**KAISER
ENGINEERS
HANFORD**

W-105-124

W-105, RESPONSE TO LOI 73

W-105, RESPONSE TO LOI 73

Figure 2
Liquid Effluent Retention Facility
KEH Containment Hydrostatic Test Rig
 (Not to Scale)

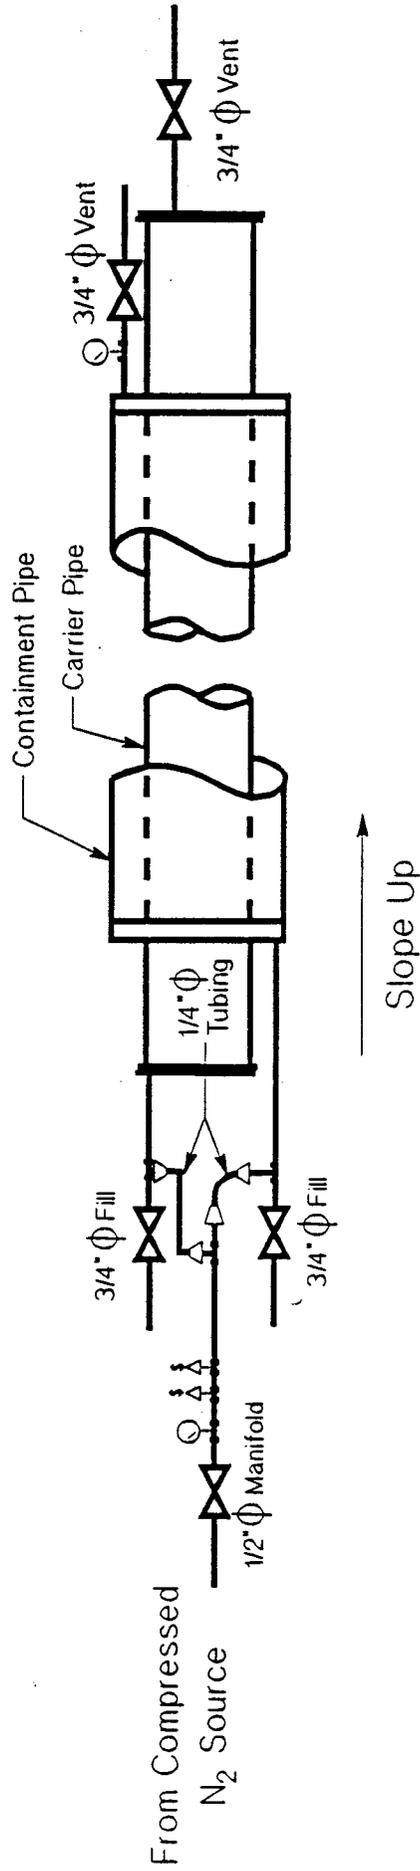
The carrier pipe and the containment pipe are required to pass separate hydrostatic tests. The carrier pipe is tested at 150 lbf/in² (gauge) and the containment pipe at 90 lbf/in² (gauge) (see Figure 2). The subject failures occurred in the 8-inch carrier pipes at some point during the hydrostatic testing operations (filling, venting, pressurizing and depressurizing) for the 12-inch containment pipe, following successful hydrostatic testing of the 8-inch carrier pipe (see Figures 3 through 6).

The pipefitter crews devised and set up the hydrostatic test rig (see Figure 2) to meet the general requirements of the applicable construction specification, W-105-C3, and Book 2 of the KEH Construction Force Manual, Procedure CFM 6.1 for hydrostatic tests. The crews also developed their own methods for filling, pressurizing, venting, and depressurizing the piping for the hydrostatic test operations. No engineering sketch or drawing of the specific test arrangement was available. Valve opening and closing sequences were carried out according to past experience and best judgement. This is apparently consistent with construction force practices at Hanford for hydrostatic testing of piping systems. However, most piping applications are of single wall design and prior to the use of fiberglass reinforced pipe, applications of double contained piping at Hanford involved carbon steel and stainless steel piping which are significantly less susceptible to failure from external pressure.

The hydrostatic test rig (see Figure 2) relied on 1/4-inch tubing connected between the carrier and the containment pipes to maintain an equal pressure between the two at all times during filling, pressurizing and venting. Two gauges were used during hydrostatic tests. One gauge was installed at the fill end and one at the vent end on the containment pipe for pressure testing of the 12-inch containment pipe. The gauge at the fill end was assumed to indicate at all times the pressure in both the 12-inch containment pipe and the 8-inch carrier pipe.

Improved field engineering support should be provided to the pipefitters, particularly when new technology is involved as in the case of double containment fiberglass pipe. Consideration should be given to development of a modified test rig for double containment fiberglass pipe that would preclude excessive external pressure on the carrier pipe during hydrostatic testing of the containment pipe.

Figure 5. Failed Section of
8-Inch Carrier Pipe
from LERF Basins 42-44
(Near Side)

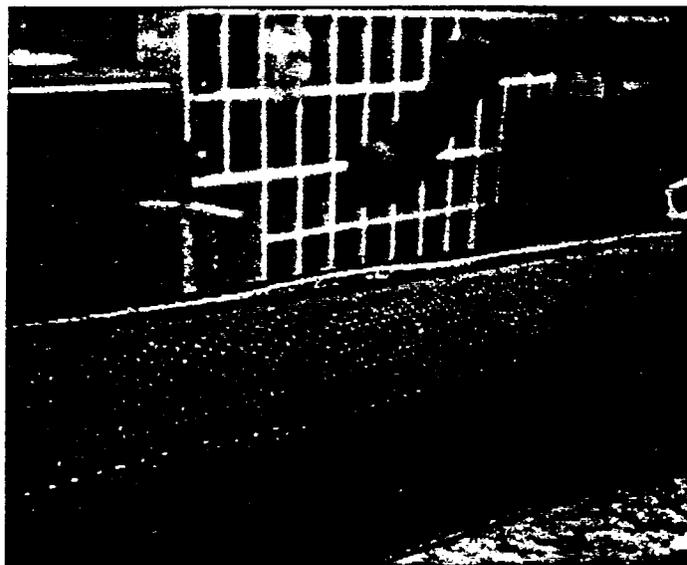
and was several inches longer on the inside than on the outside. The fracture extended between two carrier guides but had arrested short of passing through either guide. The fracture from the Basins 42-43 carrier pipe measured approximately 4 feet 5 inches, also being slightly longer on the inside. The fracture extended between a guide and bell type socket joint. The fracture extended to the end of the pipe but did not extend beyond the joint to the bell end section. The joint was separated when observed in the shop (see figure 6). The opposite end of the fracture arrested short of passing through the guide. The exterior fracture appearance was essentially unbranched and identical for both pipe sections. Both interior fractures exhibited branching and areas of delamination of the pure resin layer from the glass reinforced resin outer layer.

Figure 6. Failed Section of
8-Inch Carrier Pipe
from LERF Basin 43-44,
Bell Type Coupling

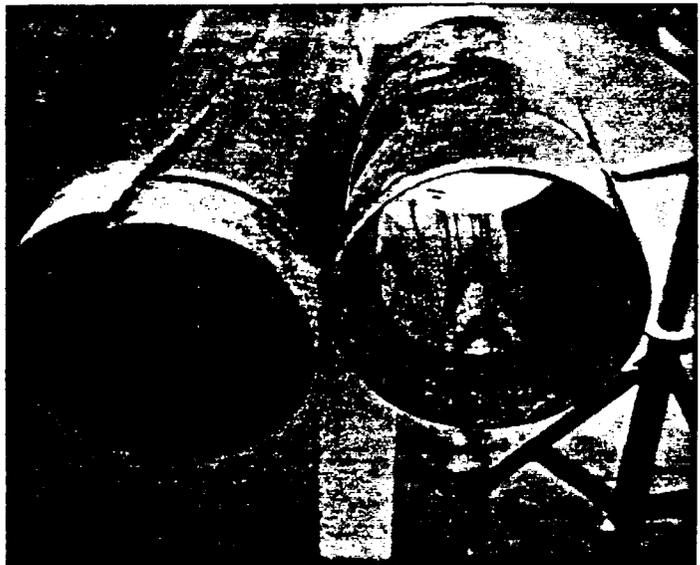
Information provided from a Fibercast engineer present for removal of the failed carrier pipe at Basins 42-43 indicated that the bell type coupling joint (see Figure 6) was still together (pipe end in bell) prior to removal of the failed section. However, the bonded joint had peeled completely around except at one small location near the top where the bond was still intact. The removal operation broke the remaining bond area and the joint separated. The fact that some bonded area remained intact suggests that the pipe end was forced radially inward by the pressure in the containment pipe.
